COUNCIL ASSESSMENT REPORT

Panel Reference	PPSSNH-30
DA Number	313/19
LGA	North Sydney
Proposed Development	To carry out alterations and additions to an existing boat repair facility and marina including the removal of slip rails, timber jetties and mooring piles and construction of a boatshed, installation of a boat crane with the capacity for 35T vessels, installation of a floating pontoon to accommodate five (5) vessels, concrete hardstand, vehicular crossing and ancillary works.
Street Address	62 Willoughby Street Kirribilli
Applicant/Owner	Pattons Slipway Pty Ltd
Date of DA lodgement	3 October 2019
Total number of Submissions Number of Unique Objections	<ul style="list-style-type: none"> 25 submissions including one from North Sydney Council and one in support to original proposal. 23 Unique Objections
Recommendation	Refusal
Regional Development Criteria (Schedule 7 of the SEPP (State and Regional Development) 2011	Regional development, as outlined in Schedule 7 of the <i>State Environmental Planning Policy (State and Regional Development) 2011</i> – marinas or other related land and water shoreline facilities, which meet the requirements for designated development under claus

3 Proposed SouthEast Elevation
Scale 1:500

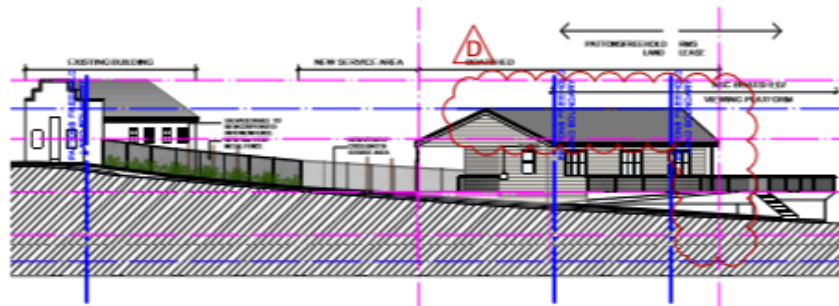
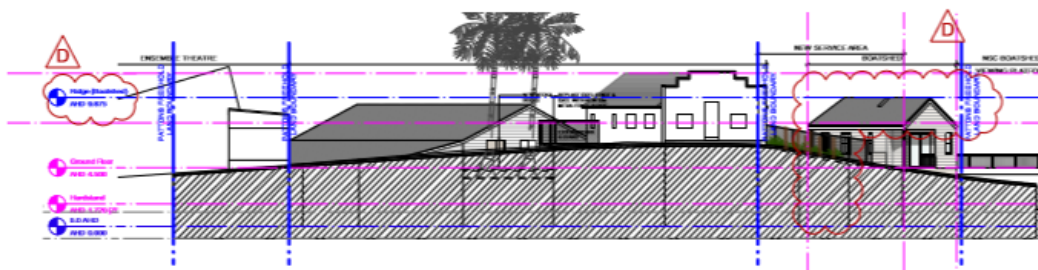
The proposed height and scale of the new boatshed is comparatively too high and does not reflect a transitory height between the flat roofed building on the one side and the height of the existing marine buildings on the other. The proposal seeks to remove any remnant structures including associated elements such as the slipways. In the absence of any compelling argument submitted for consideration and any supporting documentation from RMS, removal of the existing slipways is not supported. The slipways form part of the historic fabric significant to the site context. Demolition of these elements, although proposed to be repurposed on the site, will affect the historic character of the marina and its interpretation within the Careening Cove conservation area and should remain in situ.

The proposal is considered to have a significant adverse impact on public views and views from surrounding properties. These impacts are determinative. The upper level of the boatshed needs to be deleted or significantly reduced to minimise view impacts (and possibly provide some on-site parking). The boatshed as proposed affects views from the Ensemble Theatre, the adjacent public viewing platform, the street and residences opposite the site.

As indicated throughout the assessment, the adverse impact on public and private views are unacceptable. The upper level of the boatshed could be deleted with the reduction in the size of the hardstand to limit the number of boats stored above the water level. The crane would be obtrusive but may be acceptable if all other modifications are made. Replacement of the slipway is a limited option due to the depth of the site and the grade required to ensure that full environmental protection is available under the boat on the slip.
